**English summary of GTS' written view to the NC TAR draft code amendment decision as published on 5 March 2018 by ACM. GTS submitted its formal view in Dutch to the ACM on 25 May 2018. This English summary is for information purpose only.**

## **1. Introduction**

### **3.4. Tariff optimization**

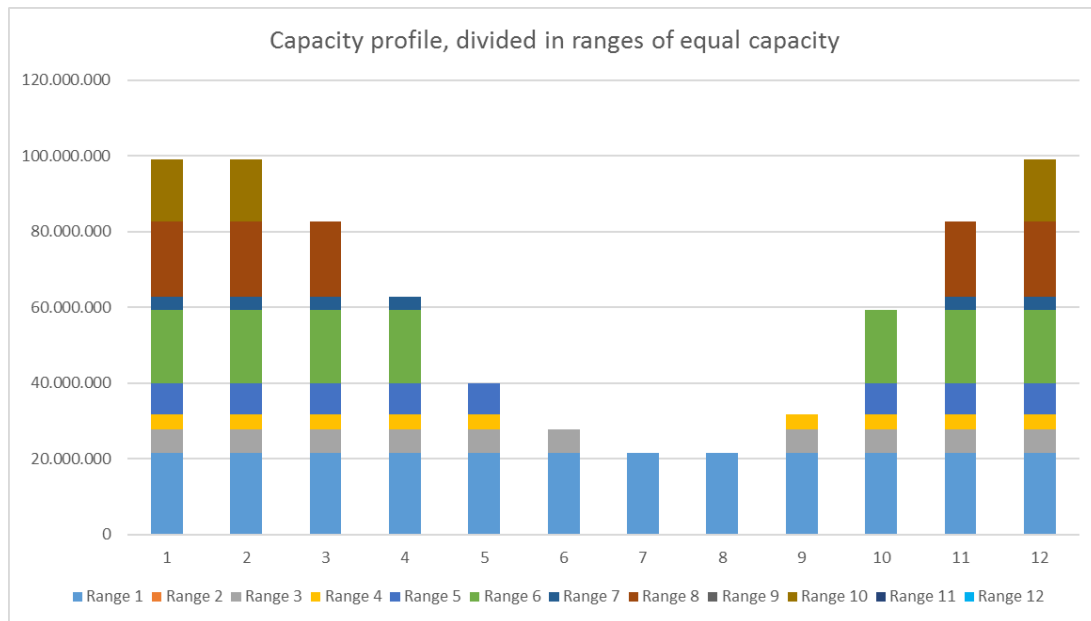
For example, shippers who want to contract a capacity profile themselves via the so-called range methodology can always achieve the cheapest solution themselves using standard capacity products with a standard price. In doing so, they will choose a longer-term capacity product per

range if the sum of the shorter-term capacity products is more expensive than the longer-term capacity product (even though they were not planning to use that capacity in all months in advance). See below for a typical RNB profile the "grey" range (range 3).

If this grey range 3 had to be contracted according to the capacity profile with quarterly products (Q1, Q2, Q4) and monthly products (September), this would cost approximately 1.14 \* the annual tariff. The shipper who has the choice himself then proceeds to purchase the annual capacity product for that range. The same mechanism can be used for the other ranges. De facto this 'product optimization' leads to an optimal booking consisting of standard capacity products with standard prices. In short: the shipper is able to realize the tariff optimization proposed by ACM through product optimization. GTS sees one possible "disadvantage" being the fact that for financial reasons capacity is booked that may not be used (possible hording). However, if we look at the current profile and period bookings, we can distinguish three groups:

GTS, on the basis of the above analysis and consideration, proposes the following text changes:

*"In case a network user on the same day contracts entry or exit capacity at domestic entry and exit points in any combination of quarterly, monthly and daily capacity products, and at request of the network user, GTS will handle as follows per capacity range:*

- a. If the price to be paid for the combination of quarterly, monthly and daily capacity products is higher than the price of an annual capacity product, the annual capacity product will be contracted for that range;*
- b. If the price to be paid for a combination of monthly and daily capacity products within one gas quarter is higher than the price to be paid for the relevant quarterly capacity product, the relevant gas quarter product is contracted; and*
- c. If the price to be paid for a combination of daily capacity products within one gas month is higher than the price to be paid for the monthly capacity product for the relevant gas month, the relevant monthly product is contracted."*
